Technical bulletin 2010-08-25 – Poseidon Diving Systems AB

Product: Poseidon MkVI Discovery Rebreather electronics module

Summary

Image 1

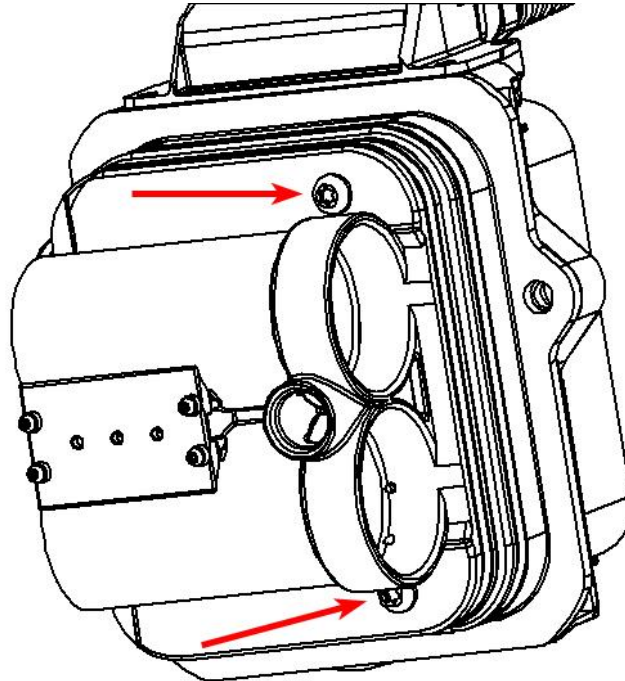
It has been found that Discovery units have been delivered with screws that have not been tightened with adequate torque. These screws are located at the bottom of the e-module - see image 1 on the next page.

The purpose of these two screws is to seal the pneumatics block and fix it, to the e-module.

All owners/users of a Discovery should check that these screws are adequately tightened, before the next dive.

1. Remove the e-module from the canister housing top.
2. Turn the e-module around, so that the bottom of the e-module is pointing upwards
3. Locate the two screws marked with red arrows in image 1 below.
4. Make sure that the two screws shown in image 1 below are tightly fastened (Recommended torque 2Nm).

Do not remove the screws or try to remove the pneumatics block - this will damage the e-module permanently.

A TORX 20 (TX 20) screwdriver
